CAUSE NO. D-1-GN-24-007463

INDEX OF APPENDICES

LETTER APPROVAL OF WATER POLLUTION ABATEMENT
PLAN

Re: Approval of a Water Pollution Abatement Plan (WPAP)
Vulcan Comal Quarry; Located SW of FM 3009 and SH 46; Comal County, Texas
Edwards Aquifer Protection Program ID No. 13001906; Regulated Entity No.
RN111942793

Figure 9. Schematic cross section with estimated topography after mining and water levels based on available data (J. Finneran, personal communication, April 16, 2024).

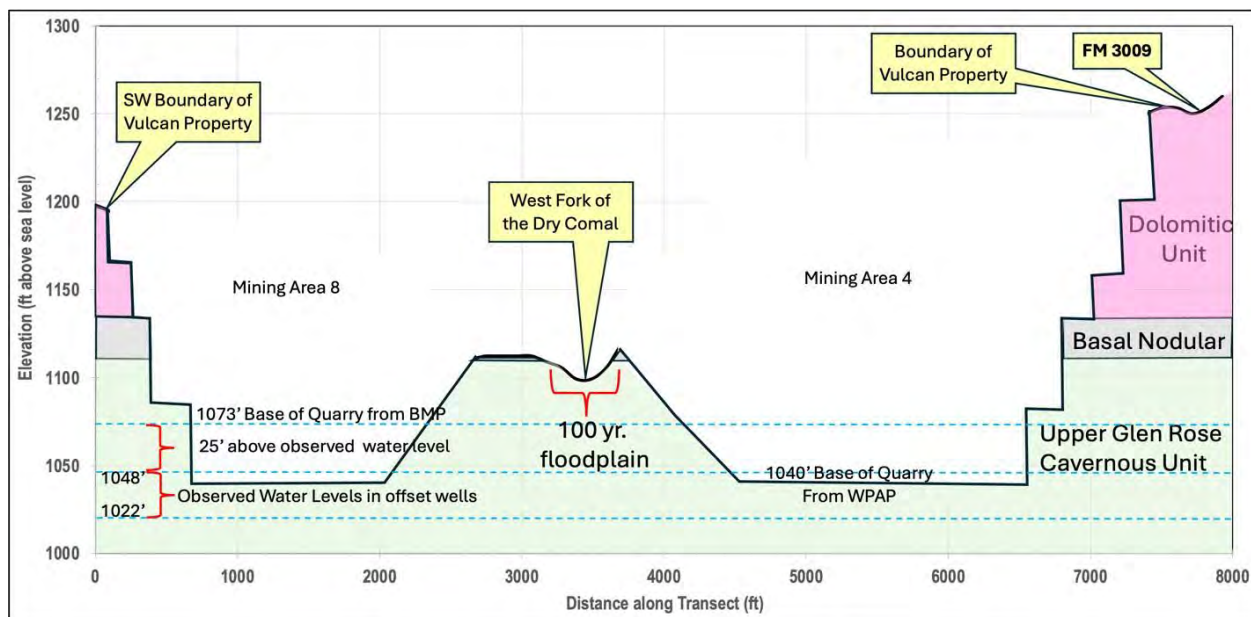
The WPAP (Pape-Dawson Engineers, 2024) for the site states that the mining areas will not be mined below an elevation of 1040 ft msl. According to the WPAP, this level of the quarry bottom will provide a 25-ft buder above the high water level of the aquifer. A review of available water-level data indicates that at times, the bottom of the quarry will be flooded by the underlying aquifer (Figure 9). Water-level data from five wells close to the perimeter of the quarry boundary were evaluated to estimate expected water levels beneath the quarry and proposed depths of the excavations (Appendix B) (J. Finneran, personal communication, April 16, 2024). The White #4 well (#520690) had a water level of 1022 ft-msl on 12/5/07. At this water level plus the 25-ft buder, the bottom of the quarry would be out of compliance. Another well (Tucker, EAA #Wxxx-137) had a water level of 1048 ft on 12/14/98. At this water level, the bottom of the quarry would be 8 ft below the water level in the aquifer.
